ADDENDUM NO. 1

**PEIRCE SCHOOL PLAYGROUND RENOVATION
Arlington, MA**

Bid No. 21-03

January 29, 2021

Drawing Title:
MATERIALS ENLARGEMENT PLANS
Sheet Number:
SK-1

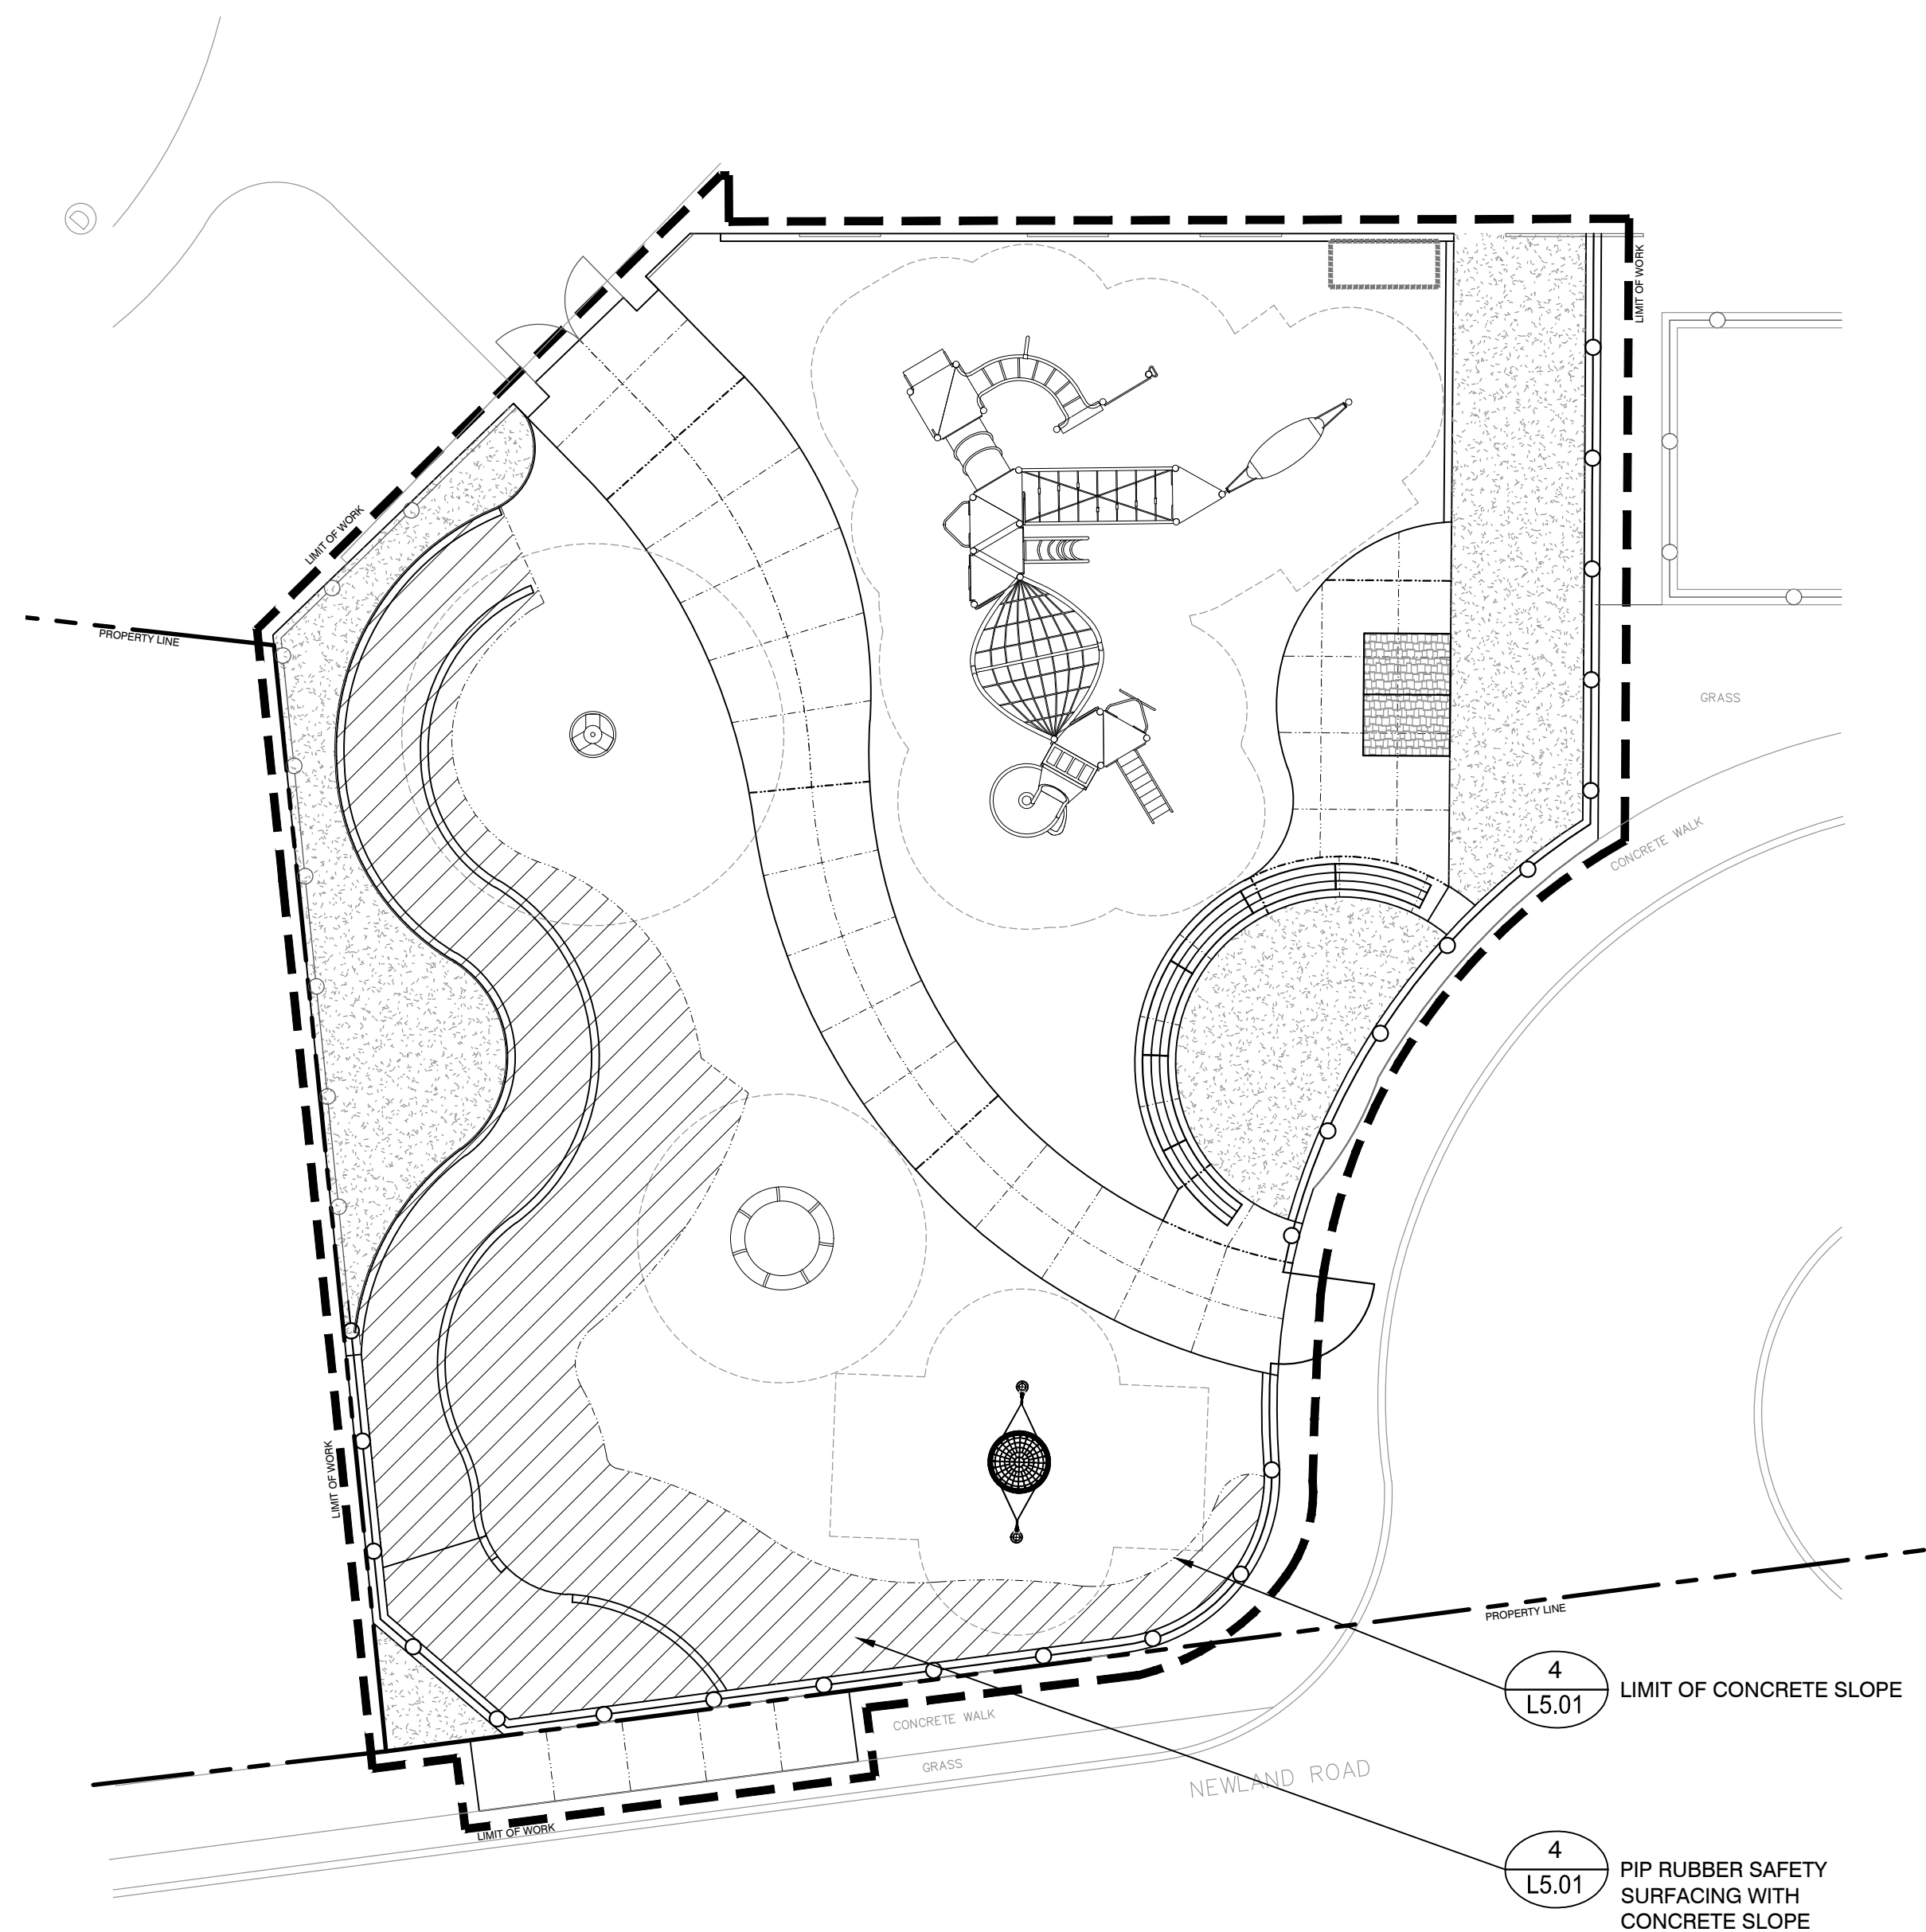
Question 2: I just wanted to let you know the scale on L3.01 Materials Enlargement Plan does not work. I'm not sure what it's supposed to be but 1-1/2" = 1' does not work.

Answer: The scale is incorrectly noted. It is 1"=5'-0", but because this is an odd scale, please refer to the attached SK-1 for plans scaled at 1"=10'-0".

SK-2

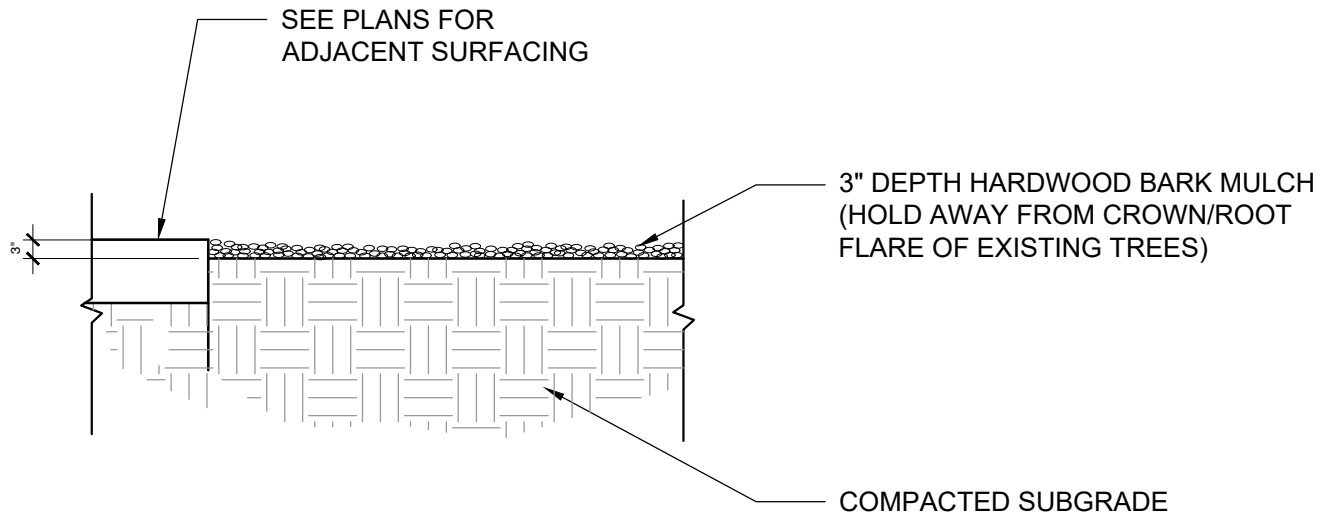
2. SHEET L5.01 CONSTRUCTION DETAILS

DELETE: Detail 6- ENGINEERED WOOD FIBER MULCH

Question 6: Please clarify the exact detail and depths of the wood fiber in the new wood fiber areas called out on the plan. Are these actual play areas or are we just placing wood fiber for weed control? Detail 6/L5.02 shows 6" of gravel? Not indicated, a layer of geotextile fabric and 12" of wood fiber. Please provide clarification, especially at existing trees.

ADD: Detail 6 (from SK-2)- HARDWOOD BARK MULCH

Answer: Contractor shall clear and grub existing planting beds to remain and remove and replace the existing mulch to a depth of three (3) inches, taking due care to avoid damage to any existing root systems. hardwood bark mulch is intended only for the planting areas, not play areas. Refer to SK-2 for the revised hardwood bark mulch detail.
